*Design Review Board*

JULY 1, 2013

**MINUTES OF A REGULAR MEETING OF THE DESIGN REVIEW BOARD OF THE TOWN OF CLARKDALE HELD ON MONDAY, JULY 1, 2013, AT 6:30 P.M. IN THE MEN'S LOUNGE OF THE CLARK MEMORIAL CLUBHOUSE, 19 N. NINTH STREET, CLARKDALE, AZ.**

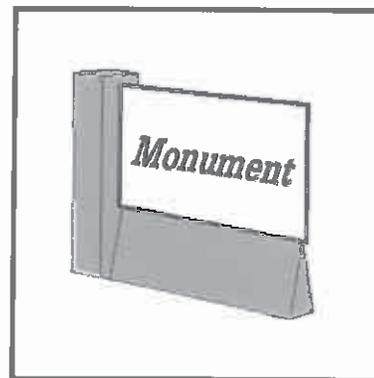
The height of the existing Pine Shadows sign exceeds the maximum allowance of four feet. The original sign was constructed prior to adoption of the overlay district however, so the existing sign is legal non-conforming. Per Section 1-6.F.3 of the Zoning Code:

The proposed alterations to the Pine Shadows sign reduces the overall height from 8' to 7.5' tall, thus reducing the non-conformity of the existing sign. In addition, the cosmetic changes proposed for the monument structure will create a more aesthetically pleasing appearance.

The Board agreed the changes were an improvement on the existing sign. Chair Prud'homme-Bauer asked for clarification regarding regulations for non-conforming signs. Senior Planner Escobar explained that the current regulations focus on non-conforming uses and there is nothing currently in the code that

Having met all code requirements, staff recommends the structure as presented be approved with the following stipulations:

1. Construction shall be as presented and comply with all ADOT restrictions.
2. Internal sign illumination shall be turned off by 10:00 p.m. every evening.
3. The Pine Shadows monument sign and installation must be inspected by the Town of Clarkdale Building Official.

quantifies the percentage of a non-conforming sign that can be altered or modified. Chair Prud'homme-Bauer requested this code be modified to include clearer guidelines for the alteration of non-conforming signs.

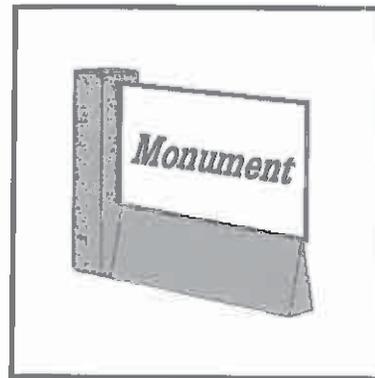
The Board agreed that the sign portion was an attractive sign, however, the poor condition of the monument base detracted from the look of the sign.

**Action/Motion:** Vice Chair Foutz motioned to approve DRB-090725, Nate's Cowboy Restaurant Monument Sign Alteration, 1481 SR 89A as presented with the recommended staff stipulations and the added stipulation 3#: *The area around the base of the monument sign shall be cleared of weeds and the monument base shall be repaired and repainted a color that complements the existing building or the sign colors. Color must be approved by staff.* Board Member Falbo seconded the motion. The motion passed unanimously.
